REPORT TO THE SUBDIVISION AND
DEVELOPMENT APPEAL BOARD

DATE: December 19, 2024	APPEAL NO.: SDAB2024-0080 FILE NO.: DP2024-05405
APPEAL BY: Mount Royal Community Association, represented by Roy Wright	
FROM A DECISION OF THE DEVELOPMENT AUTHORITY where a Revision: Single Detached Dwelling (change to DP2023-01121) was approved at <u>1425 Joliet Avenue SW.</u>	LAND USE DESIGNATION: R-CG Discretionary
COMMUNITY OF: Mount Royal	DATE OF DECISION: November 11, 2024
APPLICANT: KTRAN Design and Drafting	OWNERS: Mangala R. & Rajesh Khatri

The Mount Royal Community Association, at its Board meeting of November 19, 2024, authorized the Co-Chair of its Planning and Development Committee (PDC) to file an appeal regarding DP 2024-05405 (1425 Joliet Ave SW.) This DP was generated by neighbour and CA complaints because the developer was not following the approved plans associated with DP 2023-01121. Inspectors confirmed there were “numerous” breaches of the 2023 permit and requested the developer to apply for the new DP in 2024. The City did not disclose the number or nature of the breaches. The City advertised the 2024 application on November 14 as “Revision: Single Detached Dwelling (change to

DP2023-01121 DMAP Plans Submitted 2023-04-21 – South Elevation

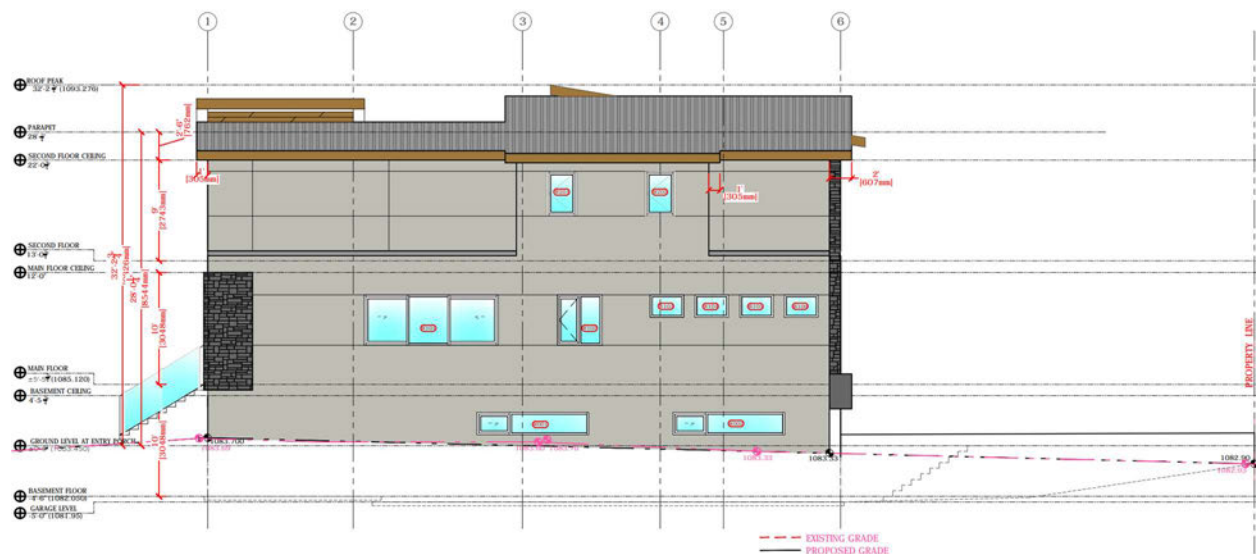
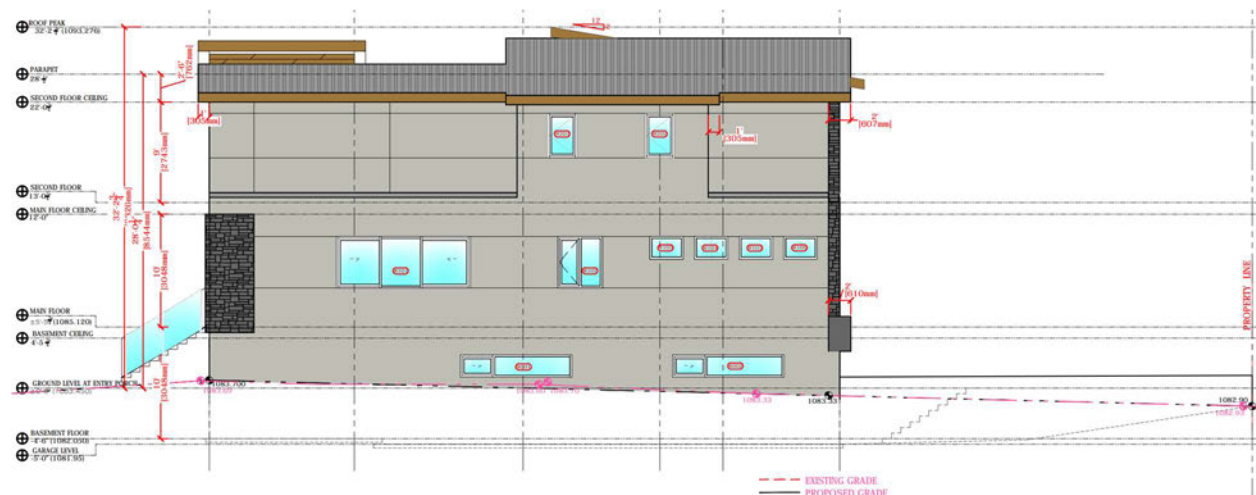
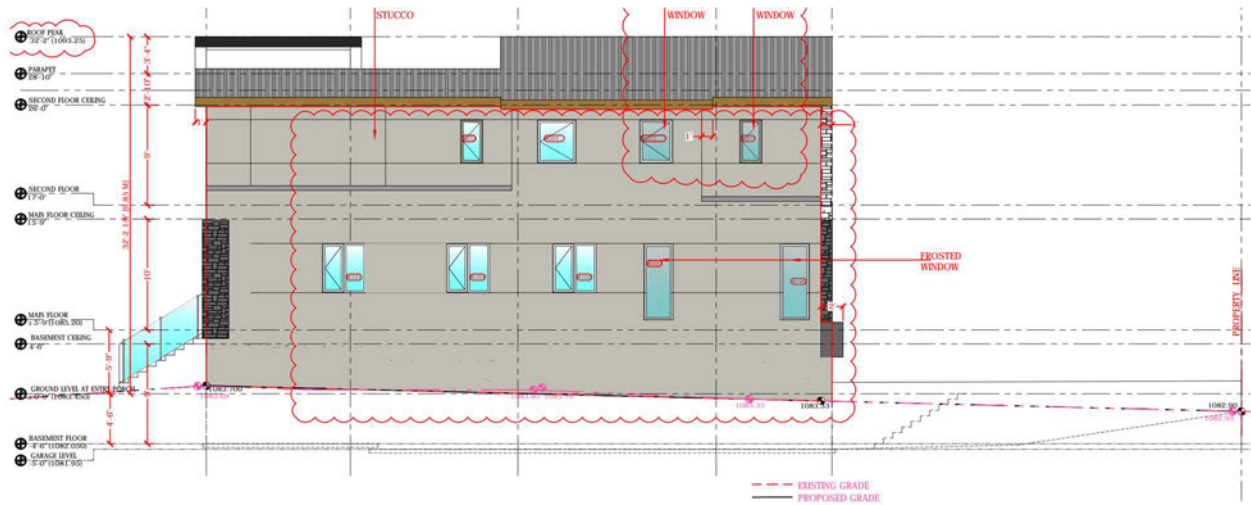
3. Loss of privacy due to changing the number, size, and types of windows on the south elevation. Original drawings indicated several transom windows on the main level overlooking the backyard of the property to the south, but windows in this area appear to be floor to ceiling windows which are not consistent with the approved plans. Windows on the second storey have increased in number from two to four and were to be frosted, but at present (as of November 30) are clear glass with the “promise” (which is not legally binding) of covering them with frosted plastic. (CA letter of August 14, 2024).

Figure 1- original south elevation

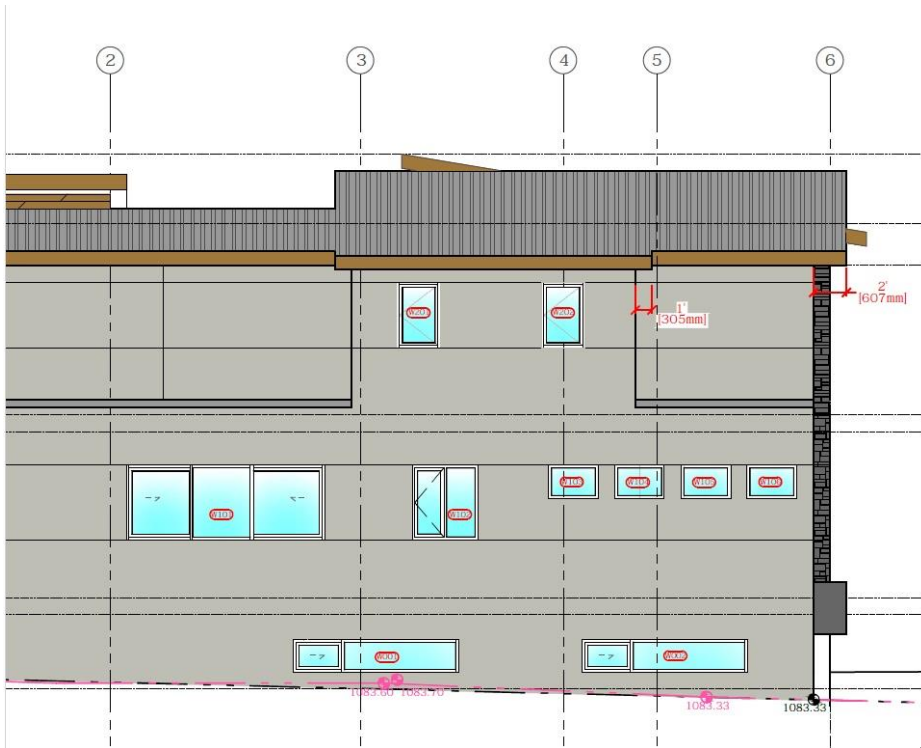
The south elevation window changes were particularly troublesome. Those windows were originally the subject of multiple meetings and emails with the owners and neighbours, and all agreed with the final decisions. (Figure 1) However, the changes, already installed as of August 12, run counter to that agreement and the original approval. The windows have increased to six full size windows (with four frosted), while the original contained four transom windows on the main floor plus two larger windows on the second floor further to the west. The present overview situation is unacceptable (Figure 2), especially given the “frosted” windows are presently clear glass with the promise they would be covered with a plastic covering to make them appear frosted. The PDC strongly recommends the original size, location and types of windows originally approved, and also negotiated as neighbours be incorporated as the final south elevation design.

Figure 3- Lot coverage areas presently not included in calculations

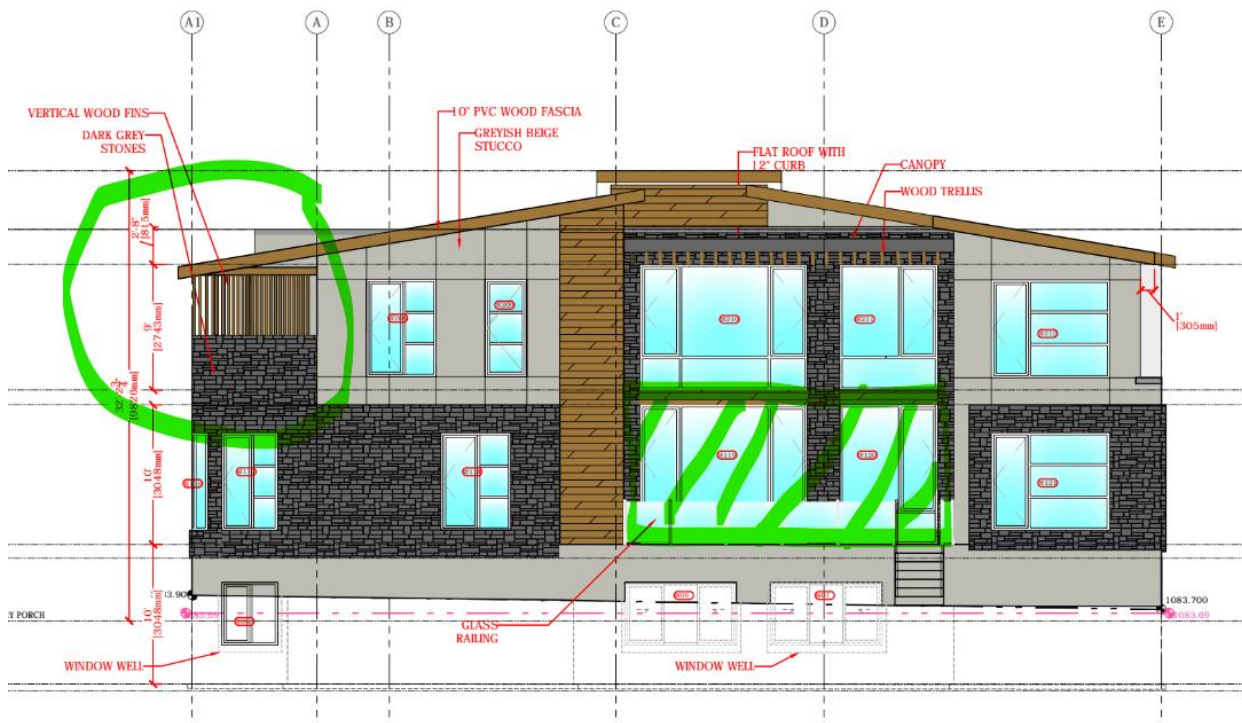
Lot coverage has increased with enclosing the patio on the west elevation and the addition of a roof over the front entry with a post to the entry landing. (Figure 3) I also think there is a potential issue with the projection of this roof over the required side yard being more than 600mm. Below is an image from the original DP. The corner balcony, circled in green was enclosed and was not that noticeable. As it is being finished now, it is completely open with what I assume will be a glass railing. The green rectangle area below, which was originally shown as a raised patio/deck is now fully enclosed with proposed garage doors on the 14th street elevation. This will not be an attractive feature for the street frontage.

Figure 1- original south elevation

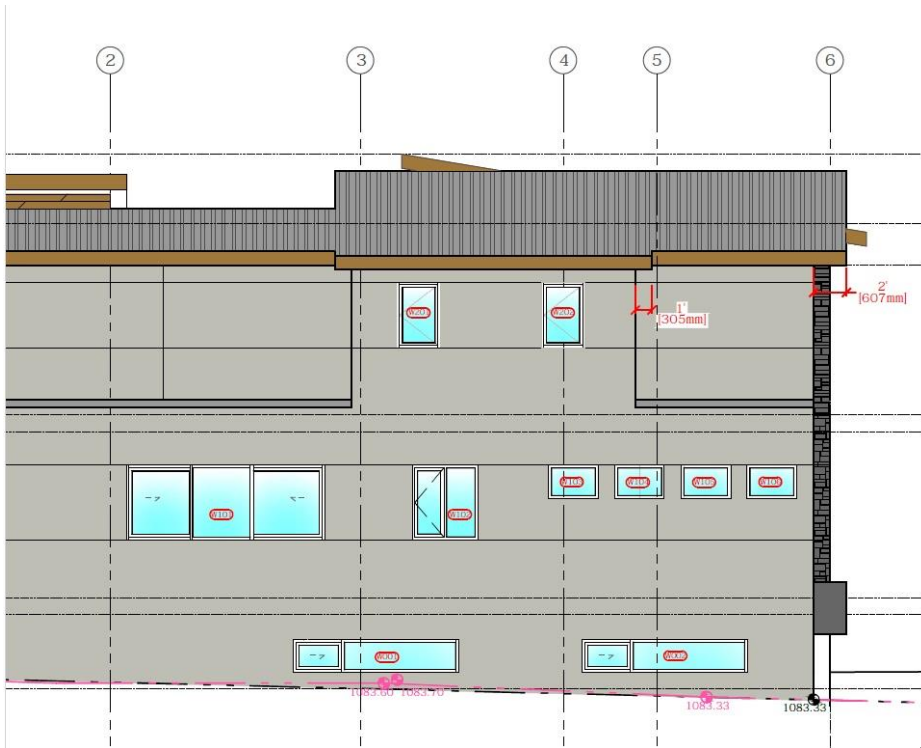
The south elevation window changes were particularly troublesome. Those windows were originally the subject of multiple meetings and emails with the owners and neighbours, and all agreed with the final decisions. (Figure 1) However, the changes, already installed as of August 12, run counter to that agreement and the original approval. The windows have increased to six full size windows (with four frosted), while the original contained four transom windows on the main floor plus two larger windows on the second floor further to the west. The present overview situation is unacceptable (Figure 2), especially given the “frosted” windows are presently clear glass with the promise they would be covered with a plastic covering to make them appear frosted. The PDC strongly recommends the original size, location and types of windows originally approved, and also negotiated as neighbours be incorporated as the final south elevation design.

Figure 3- Lot coverage areas presently not included in calculations

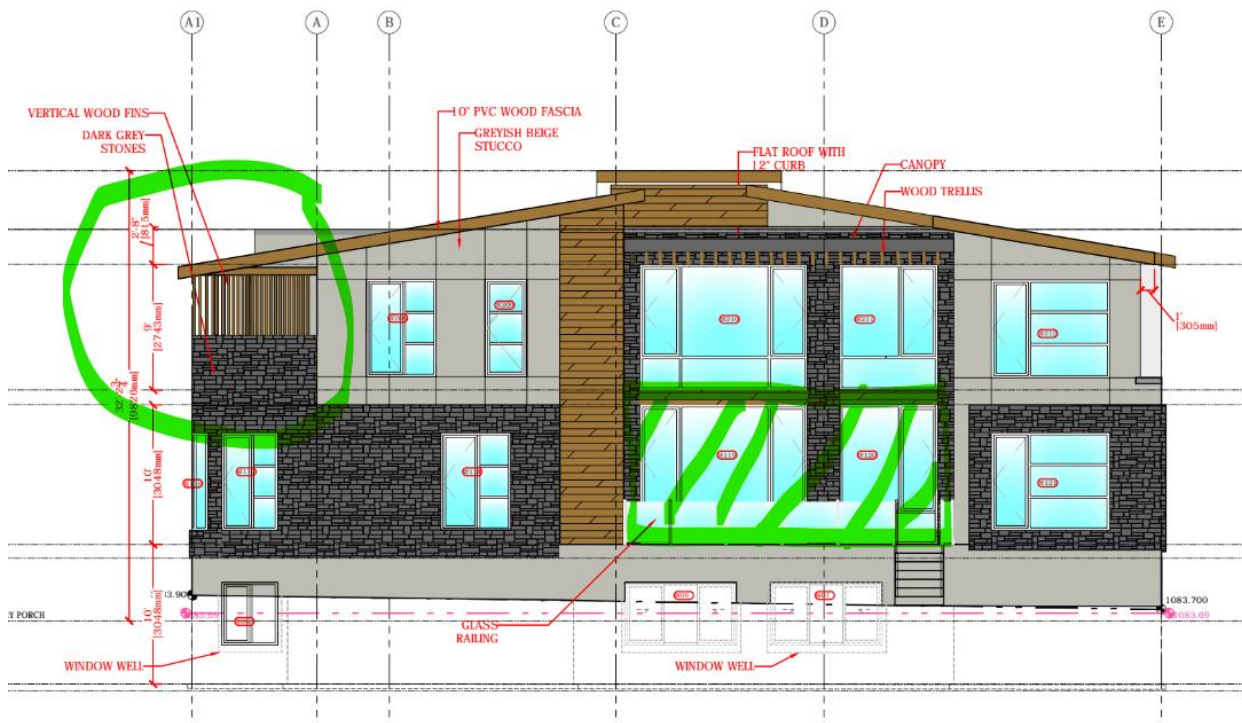
Lot coverage has increased with enclosing the patio on the west elevation and the addition of a roof over the front entry with a post to the entry landing. (Figure 3) I also think there is a potential issue with the projection of this roof over the required side yard being more than 600mm. Below is an image from the original DP. The corner balcony, circled in green was enclosed and was not that noticeable. As it is being finished now, it is completely open with what I assume will be a glass railing. The green rectangle area below, which was originally shown as a raised patio/deck is now fully enclosed with proposed garage doors on the 14th street elevation. This will not be an attractive feature for the street frontage.

Figure 3 - view with proposed building.

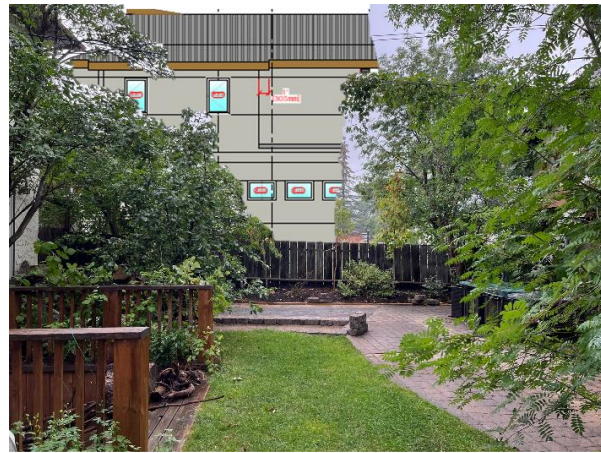
Our property will have a full 2+ Storey high wall along our north facing property line, almost twice as long as the width of our house. The proposed wall will have minimum 8 windows of various sizes directly overlooking into our garden, seriously infringing on our privacy (see Figure 2 and 3).

Figure 6 – Blue area absorbs water through ground.

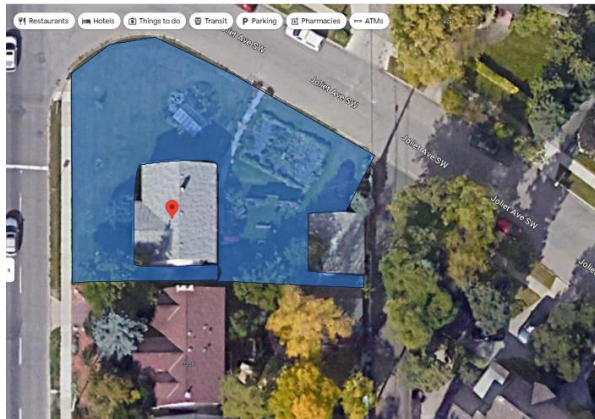
The second issue is that while rain water and snowmelt water are currently vastly absorbed by the soil on the ground throughout the parcel, the sheer size of the proposed building will seriously reduce the amount of water that the remaining grounds can absorb (see Blue area in Figure 5 & 6).

Figure 5 - The size of the proposed building reduces the area for water absorption. Green area = additional water to drain away current ground absorbing surface water (blue area)

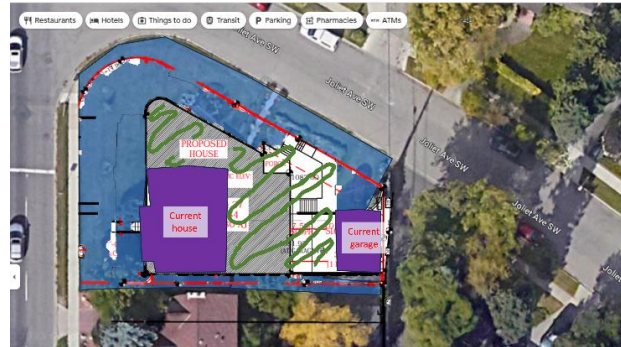
Since less water will be absorbed through the soil, more water will accumulate on the roof and other covered areas and will need to be drained. The water will therefore follow the easiest path which will be south toward our property.
